SUBJECT: Final Construction Completion Report for SEAD-25 and SEAD-26; Seneca Army Depot Activity, Contract FA8903-04-D-8675, Delivery Order 0012, CDRL A001C

SUBJECT: Final Construction Completion Report for SEAD-25 and SEAD-26; Seneca Army Depot Activity, Contract FA8903-04-D-8675, Delivery Order 0012, CDRL A001C

**Seneca Army Depot Activity
Romulus, New York**

C-1
TITLE SHEET

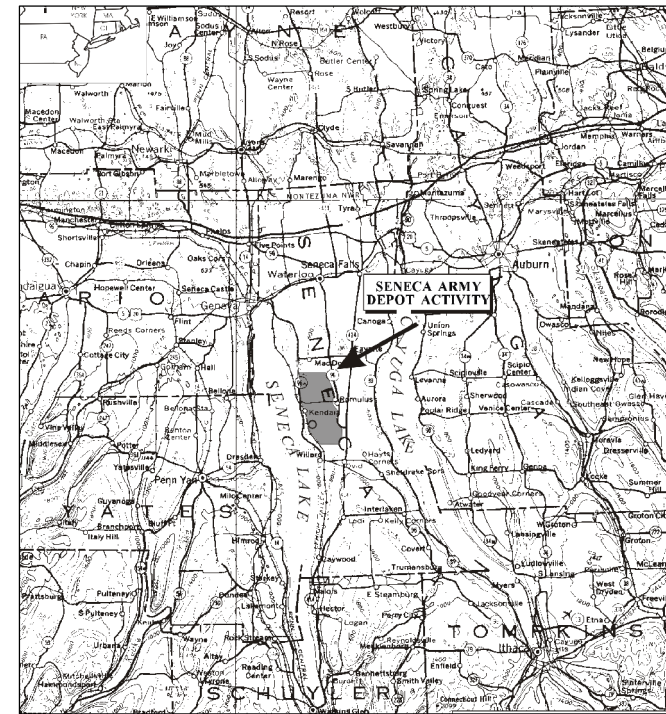
Comment 2: Drawing C-1, "Title Sheet." This map does not show NY State 96A as stated on page 1-2.

C-6
EXCAVATION PLAN
SEAD-26

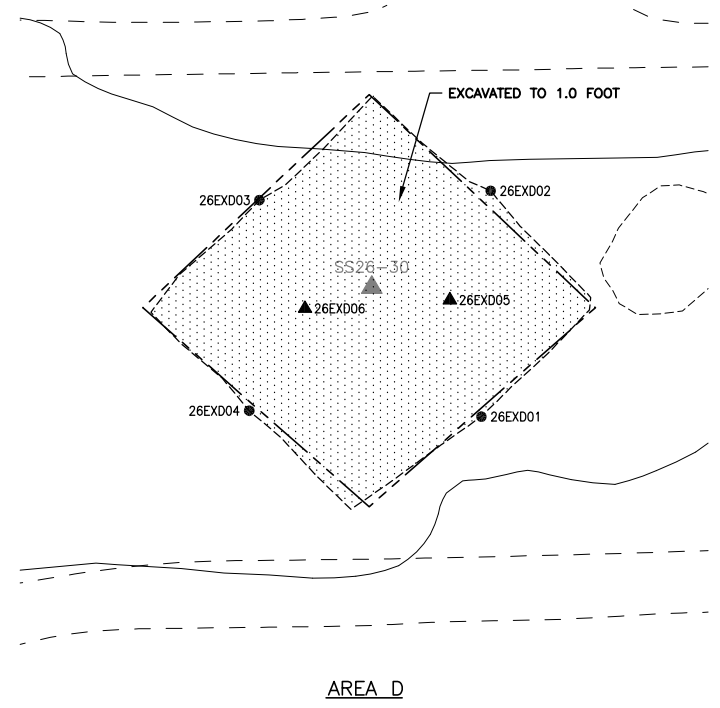
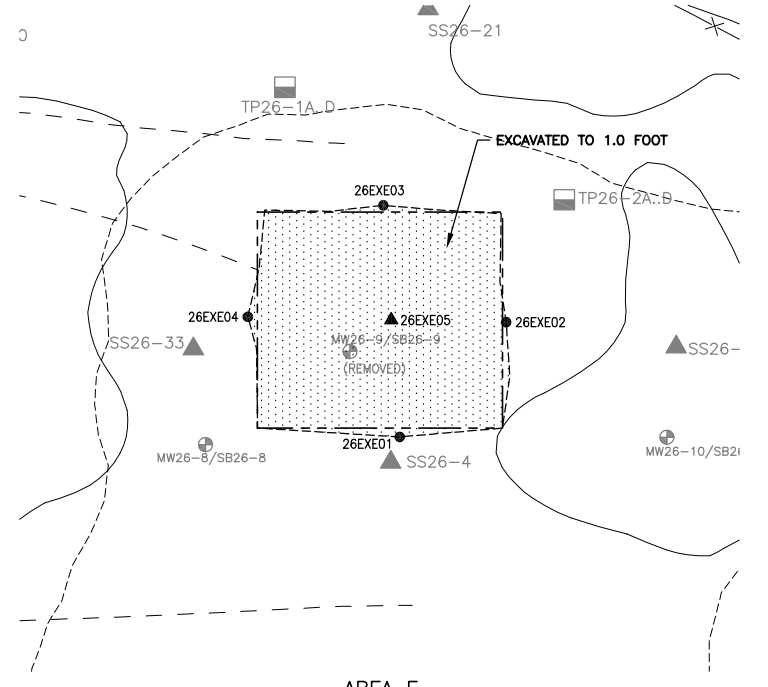
Comment 3: Drawing C-6, "Excavation Plan", SEAD-26. Sample 26EXA05 is shown to the north of the Area A excavation limits. Please revise drawing C-6 to show the Sample 26EXA05 at the northern sidewall of Area A. Also, MW26-9 cannot be located on this map as indicated in page 2-3.

Response 3: As shown in Drawing C-6, Sample 26EXA05 is located on the northern edge of the eastern sidewall of the excavation. Clarification is needed to understand the question regarding this location. MW26-9 is located in the middle of Area E on Drawing C-6 and is screened to indicate that it has been abandoned. Its location is more clear on the larger size drawings provided in the report.
